**Minutes of SPIRE Grounding Review**  
**RAL, 23, 24 Sept. 2002**  
**SPIRE-UCF-MOM-001405**  
**Matt Griffin, Oct. 10 2002**

### **9. Technical Meeting 1: Identifying an Agreed Grounding Scheme**

## 11. Advisers' comments

### HERSCHEL SPIRE GROUNDING SCHEME

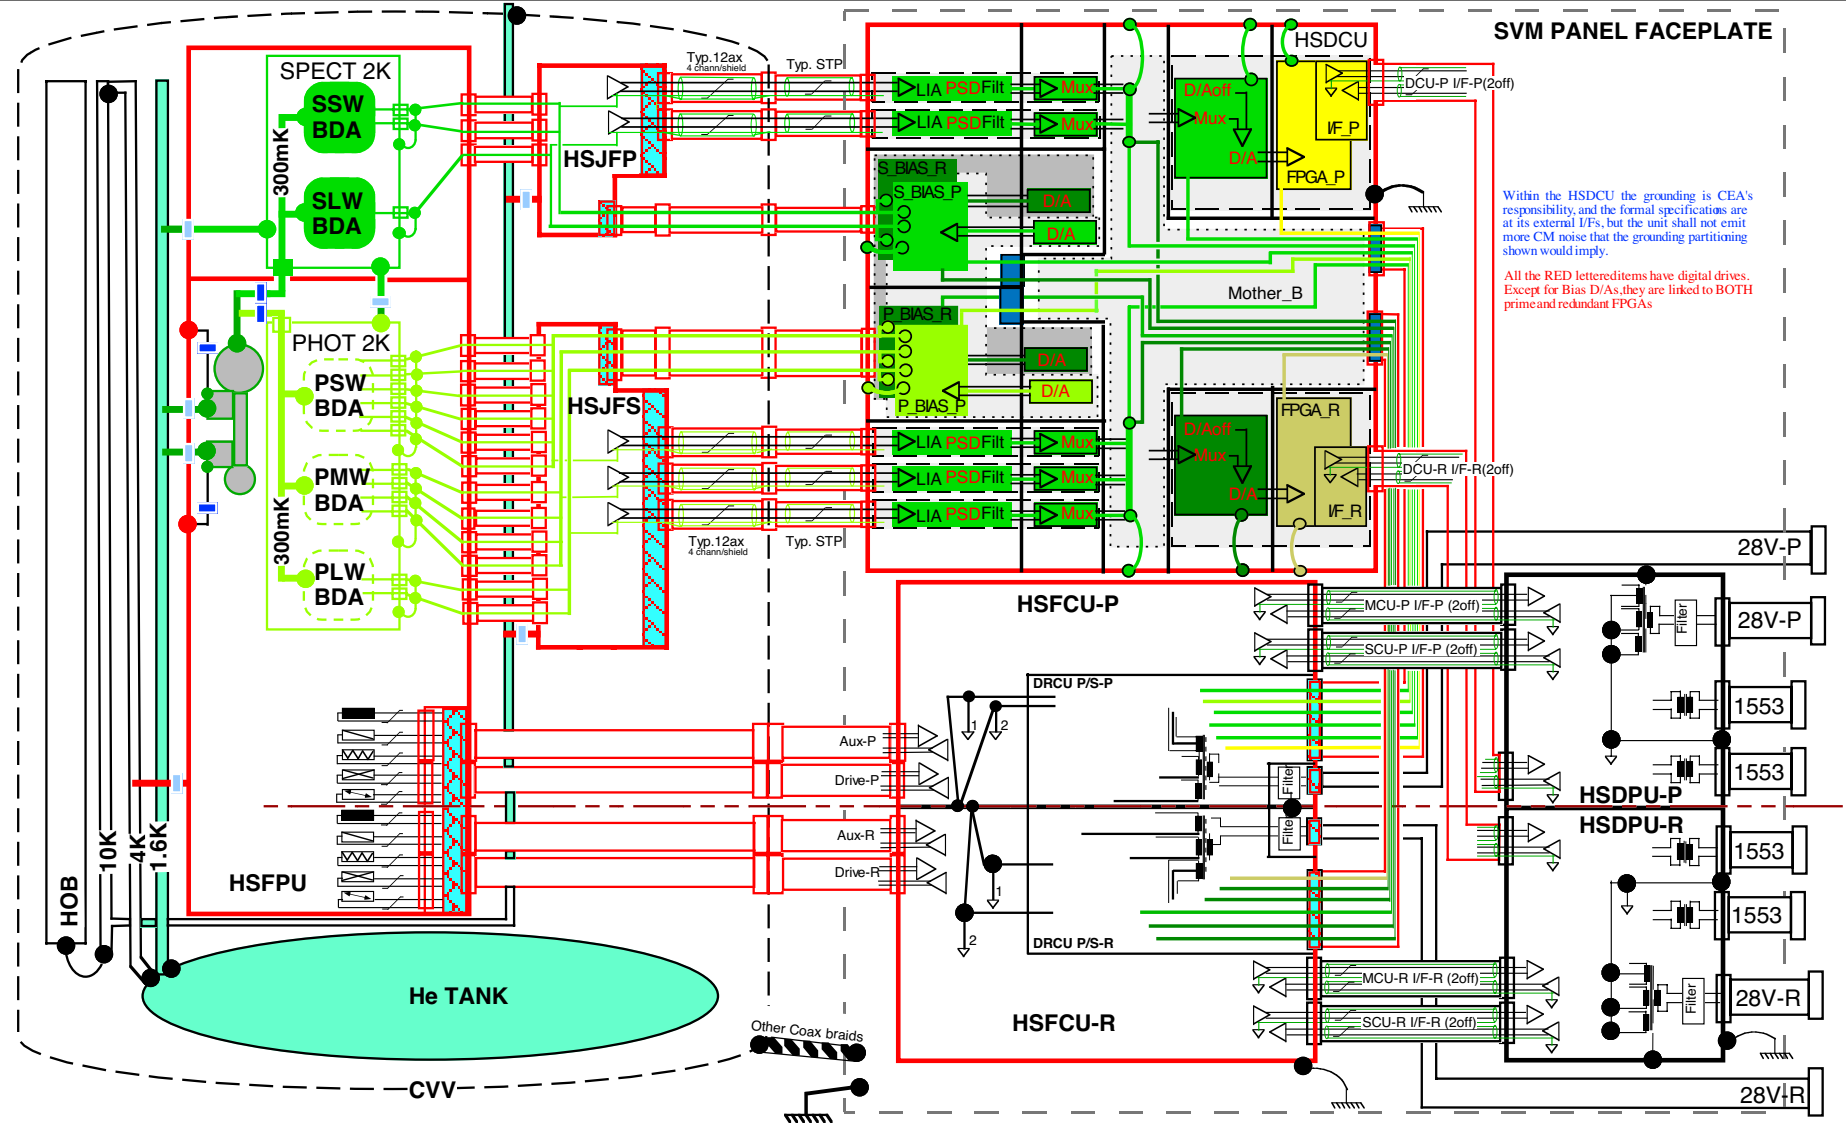
Within the HSDCU the grounding is CEA's responsibility, and the formal specifications are at its external I/Fs, but the unit shall not emit more CM noise than the grounding partitioning shown would imply.

EMI Power Dissipated On The Bolometer in the cold-end grounding case (green) and in the warm-end grounding case (red)

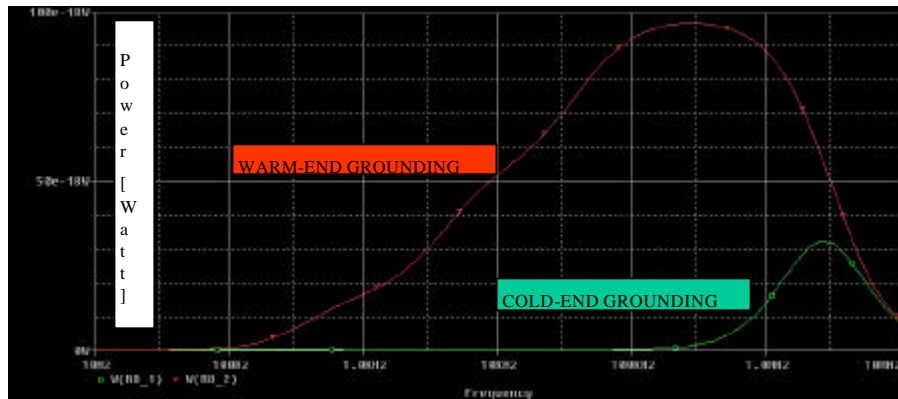
The WARM-END grounding scheme is more susceptible to a EMI acting between the warm electronics frame ground and the dewar (the 10 mA source).
